## Directorate of Airspace Policy

### **MIDLANDS PHASE 2 (DTY Extension) AIRSPACE CHANGE REVIEW**

Midlands Airspace Change Proposal (ACP) Phase 2 was introduced on 24 Nov 05. This report details the outcome of a review of the effectiveness of the ACP, 12 months after implementation.

**Figure 1: New A34 extension with respect to the Shropshire Hills AONB**

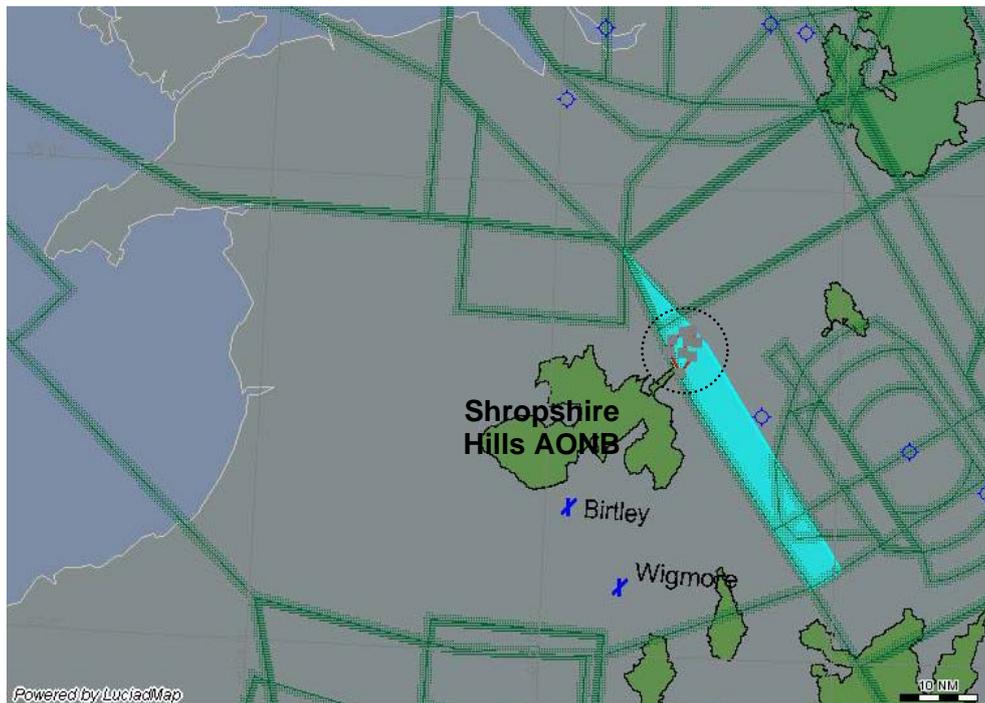
The new airspace base FL145, overlies a portion of the Shropshire Hills (the Wrekin), which was not over-flown prior to the change. This area is shown circled in Figure 1. NATS believed that the proposal took due account of the required environmental issues whilst also enabling an **efficient** enhancement to the airspace structure. By introducing systemisation of traffic, the airspace structure was designed to deconflict traffic flows; this results in less controller intervention, increasing capacity and helping to ensure more aircraft attain their optimum climb/descent profiles.

Figure 1, on page 3, shows that only a small extremity of the Shropshire Hills is over-flown by aircraft using the A34 extension and the majority of the AONB is avoided by the A34 extension. Data provided also indicates that above FL145 there is an average of less than one aircraft per hour over-flying the area.

Figure 3: Average number of aircraft per hour over-flying the Shropshire Hills AONB (the Wrekin)

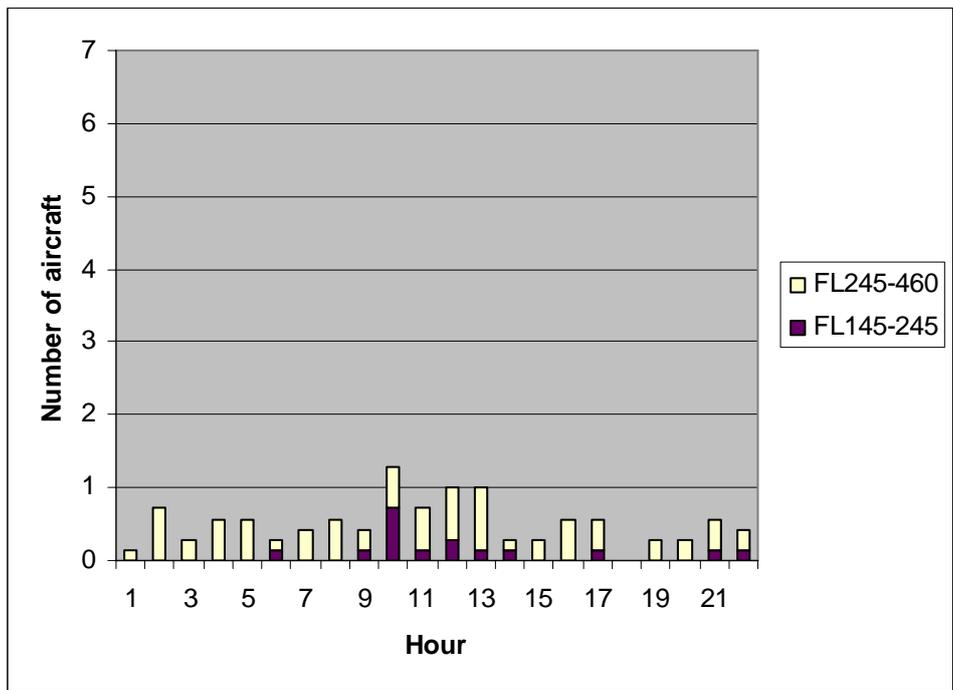
Figure 3 is similar to Figure 2, but only includes those flights that passed over the north eastern extremity of the Shropshire Hills AONB in the new airspace. Other than military and recreational general aviation (GA) flights, there were no recorded civil air traffic flights in uncontrolled airspace below FL145 over this area. The average total number of flights per busy summer day using the new airspace and crossing the AONB, for the period examined, was 11.1 flights per day.

**Figure 5: Delays generated by Daventry sectors Jan 2004 – Apr 2007 (new airspace introduced Nov 2005)**

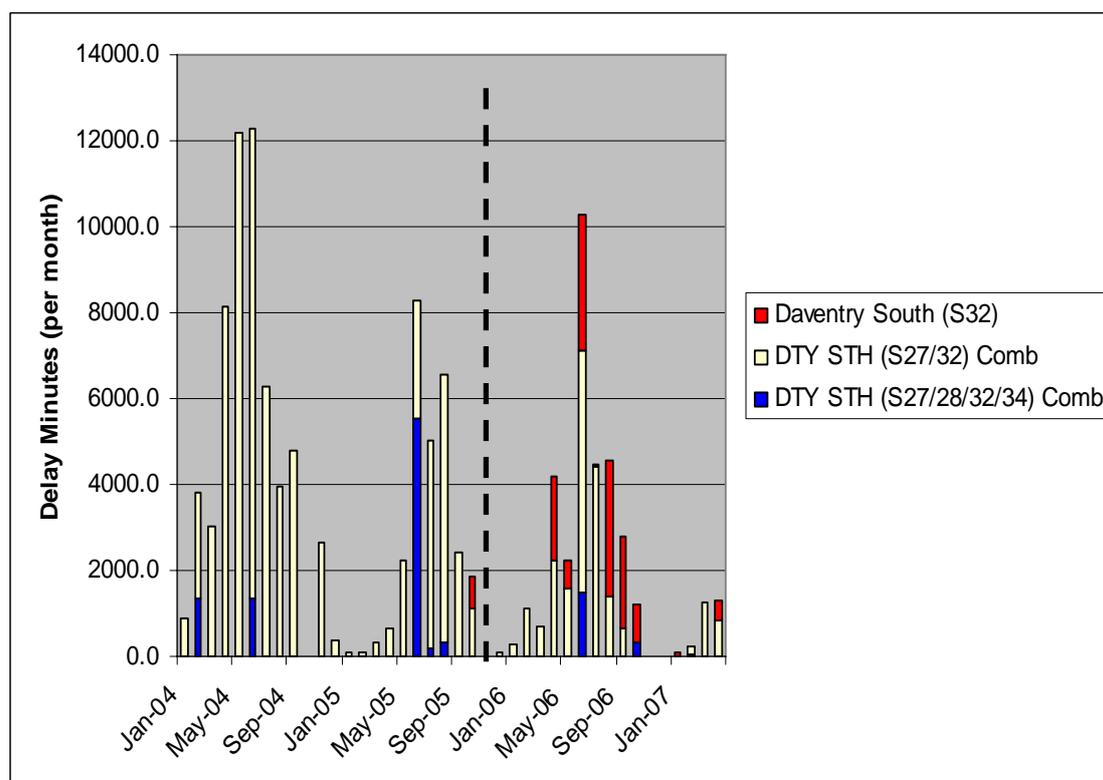
Following implementation, TC Cowly did not generate any delays up to and including April 2007; the delays for S27/32 (DTY STH) and S27/28/32/34 (DTY) decreased. However, S32 on its own has shown a subsequent rise in delays experienced; two key issues have been identified as the causal factors:

- A significant increase in traffic, particularly Low Cost Carriers operating out of Liverpool, Blackpool, Doncaster and Nottingham East Midlands airfields.
- Since December 2006, the traffic flow manager (Network Manager), in conjunction with the Local Area Supervisors concerned, will work out the least penalising regulation that can be used to manage the spine of the UK. Experience has shown that often, a S32 regulation can control the demand in Lakes, Manchester S29, DTY S, TC Cowly, LUS, LMS and S18. As a result, S32 has been used increasingly as the 'control valve' to regulate a large part of the ATC system.
